STAFF REPORT 9-22-2021 SPECIAL MEETING APPLICATION NUMBER: 21-7476 VIOLATION NUMBER: 21-444 ADDRESS: 4260 FULLERTON AVENUE HISTORIC DISTRICT: RUSSELL WOODS – SULLIVAN APPLICANT: WILLIAM WROBLEWSKI, CANDY CONSTRUCTION PROPERTY OWNER: SAMEL JASER, DTT RENOVATION GROUP DATE OF PROVISIONALLY COMPLETE APPLICATION: 7-23-2021 DATE OF STAFF SITE VISIT: 9-14-2021

SCOPE: WINDOWS, ROOF AND DOORS REPLACED WITHOUT APPROVAL – **WORK COMPLETED WITHOUT APPROVAL**

4260 Fullerton. View from Arden Park Boulevard looking northwest. Photo taken by HDC staff, June 28, 2021.

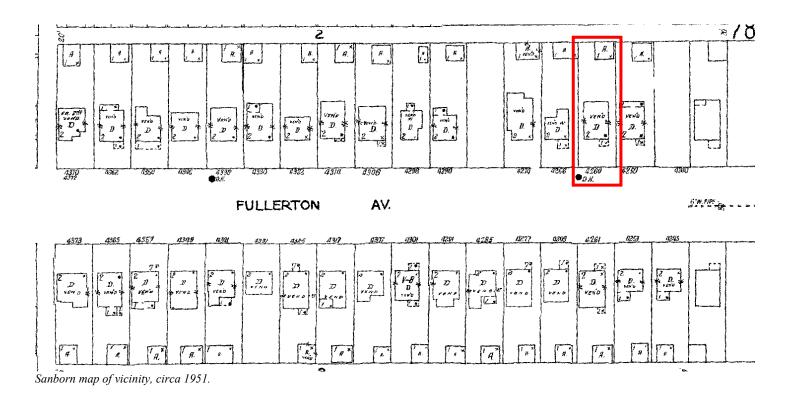
4260 Fullerton. Google Street View – June, 2019 – Note steel windows at bay on front of house & wood front entry door.

4260 Fullerton. HDC Staff photo – May 10, 2021 – Site visit based on reported violation of work being done without approval. Note window replacement, roof replacement, front door replacement, metal railing removal.

4260 Fullerton. HDC Staff photo – September 14, 2021 – Routine site visit by staff as part of the application and staff reporting process. Note window replacement, roof replacement, front door replacement, metal railing removal. Additionally, staff observed the painting of the front stucco & half-timbering which is additional work that has happened since May without approval from the HDC.

- Front gable (stucco and half-timbering) has recently been painted gray and white (see photos on previous page). It is staff's opinion that this color scheme is inappropriate for both the architectural style of the house and the traditional expression of half-timbering in this District.
